# **New Egress Window Plan** for Proposed Bedroom (sleeping room)

# Permit Revision Submittal Requirements and Application

### Life Safety Checksheet Response

Permit #: <u>20-222003-REV-01-RS</u> Date: 8-17-2021

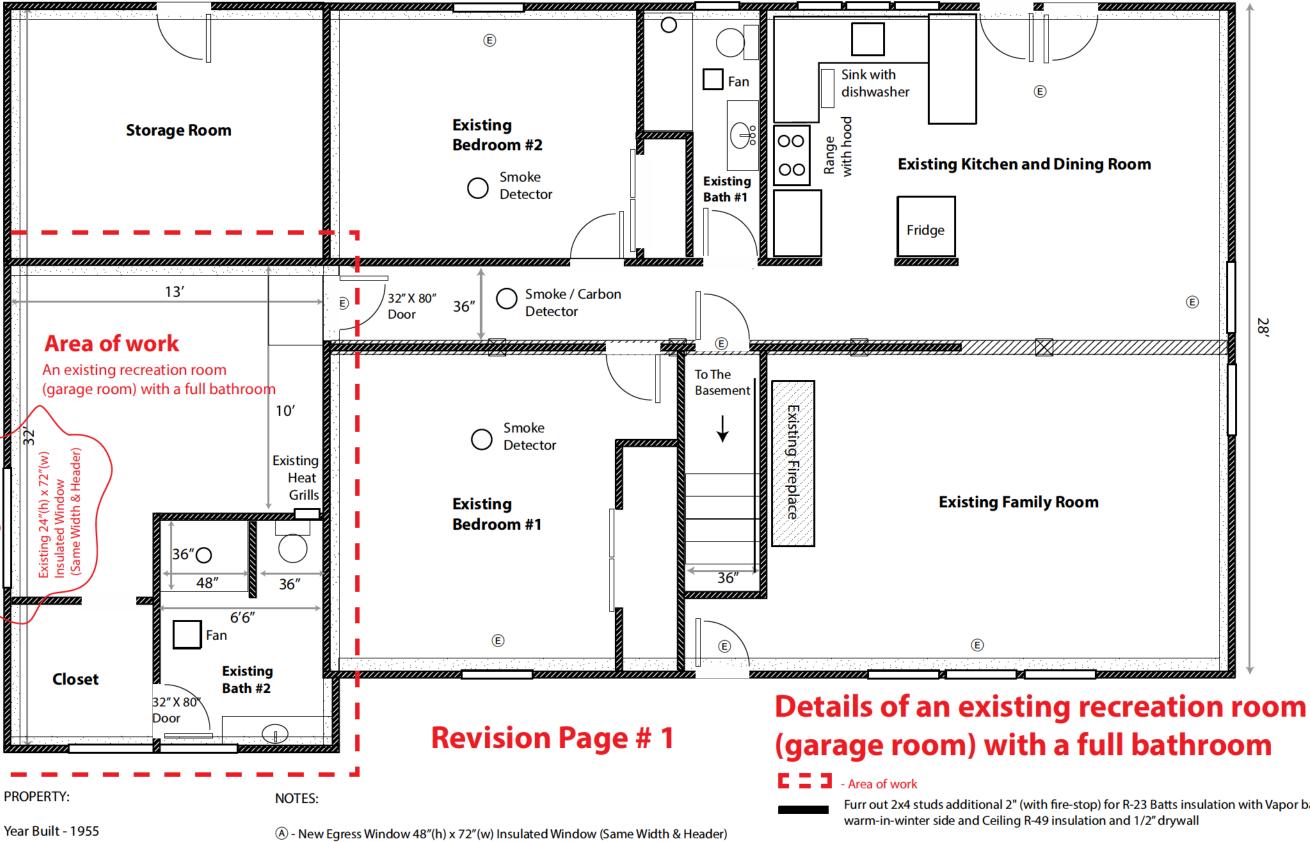
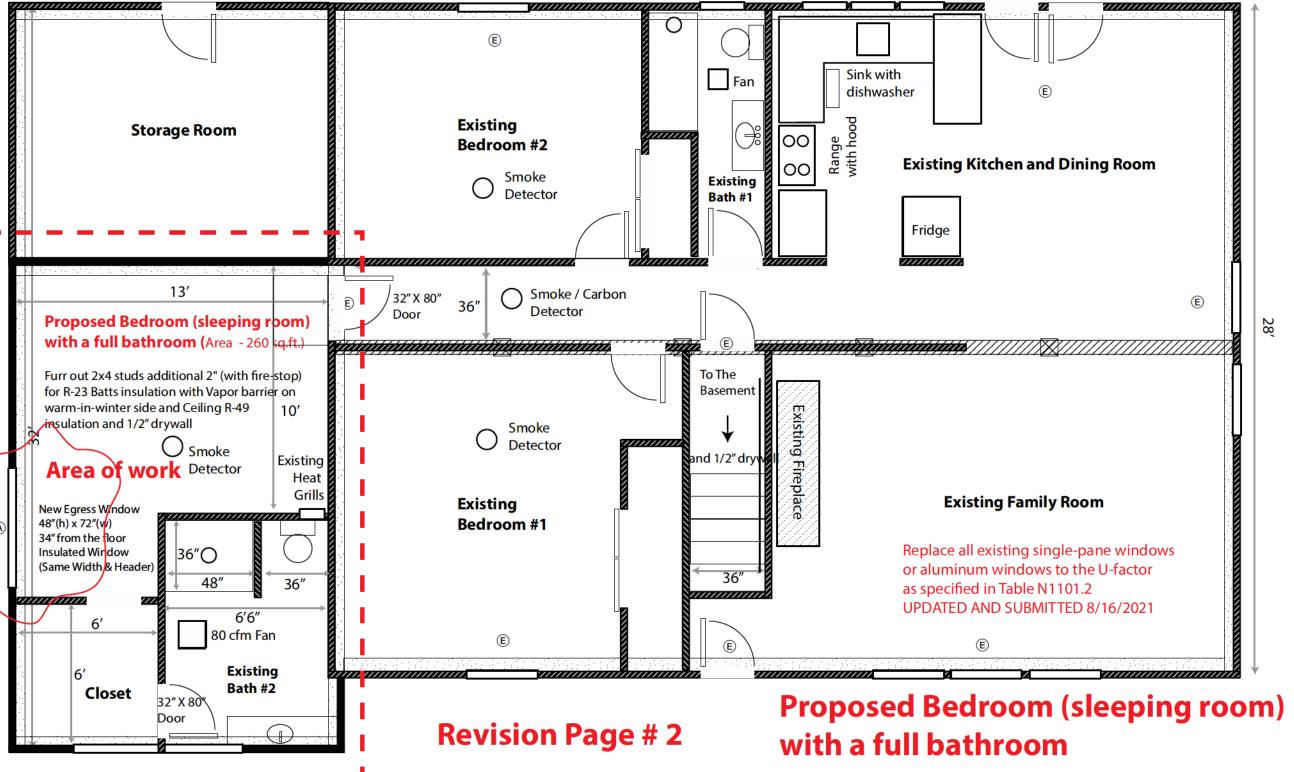
Checksheet item number	Description of changes, corrections, additions, etc.	Location on plans
1	Existing 24" (h) x 72" (w) Insulated Window (Same Width & Header)	R-1, R-2
2	36" in height permanent fence with the access gate door. Remove off-street parking by putting a physical barrier between the street and the paving on the lot.	R-4

A - New Egress Window 48"(h) x 72"(w) Insulated Window (Same Width & Header)

B - Existing 24""(h) x 72"(w) Insulated Windows (Same Width & Header)
